Consumers
Power
Company

Re: Docket 50-155

Transmitted herewith are three (3) executed and nineteen (19) conformed copies of a request for a change to the Technical Specifications of License DPR-6, Docket No. 50-155, issued to Consumers Power Company on May 1, 1964, for the Big Rock Point Nuclear Plant.

Regulatory Supply File Case
Request for Authorization of Change in Technical Specifications

FIGURE 5-6. DRAWING OF 7 x 7 FUEL LATTICE CENTERMELT BUNDLE

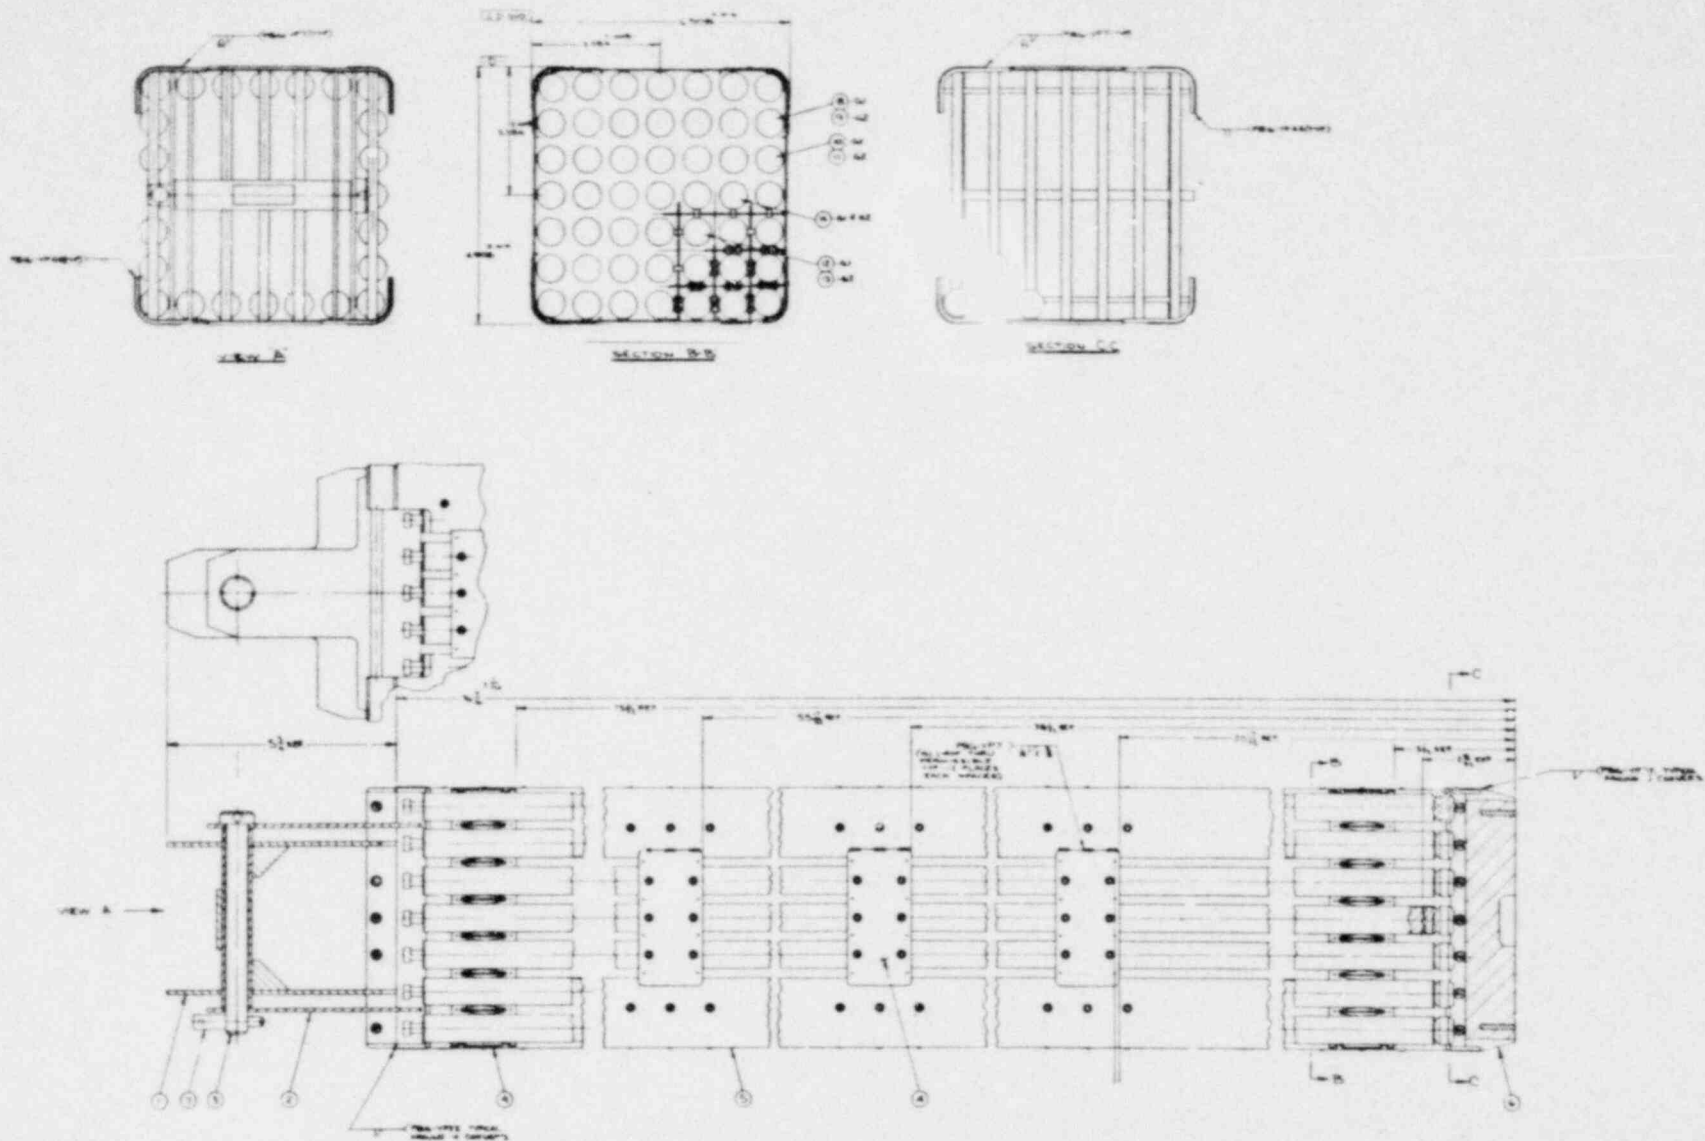
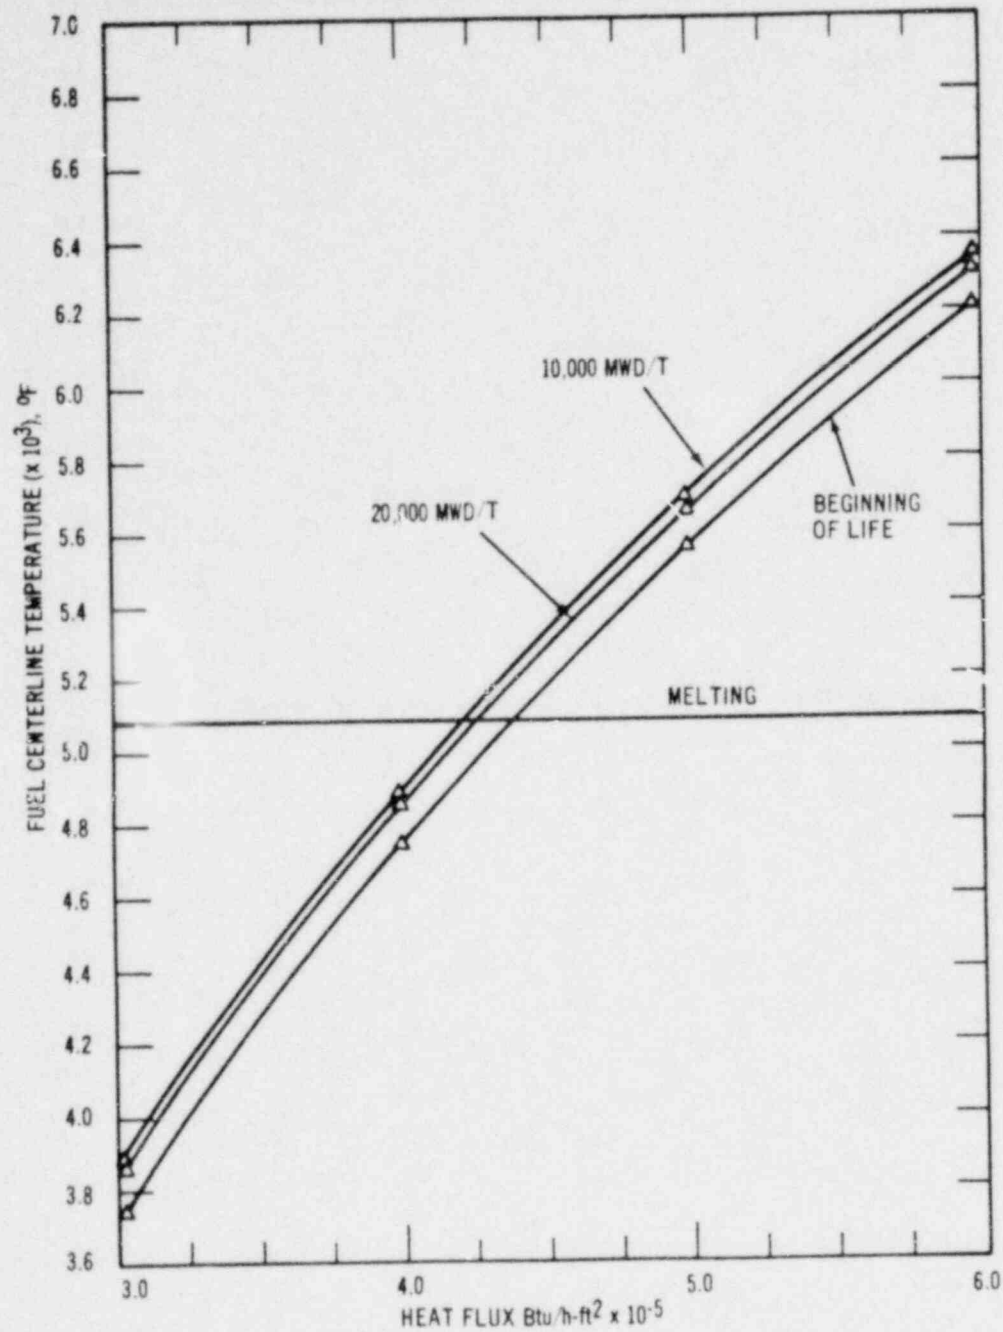
- B. Add Figures 5.5 and 5.6 (8 x 8 and 7 x 7 Fuel Drawings).
C. Add a column to the table in Section 5.1.5 (c) as follows:

The centermelt fuel bundles described above and shown in Figures 5.5 and 5.6 are the same basic mechanical design as the Reload "B" and "C" and the Phase I and II R&D bundles. Experience to date with this design has been excellent and there is no reason to expect problems arising out of the design.

"The general dimensions and configuration of the types of fuel bundles shall be as shown in Figures 5.2, 5.3, 5.4, 5.5, 5.6 and 8.1 of these specifications. Principal design features shall be essentially as follows:"
